## **SERVICE BULLETIN**

**APPLICABILITY:** 2019-24MY Forester **NUMBER:** 07-218-23R

SUBJECT: Genuine Alternative Battery Replacement

REVISED: 06/04/24

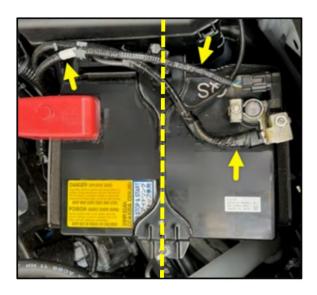
STEP 4: Install the NEW battery cover (p.n. 82123AN000) to the alternative replacement battery. Confirm the bottom of the cover is aligned flush with the bottom of the battery.
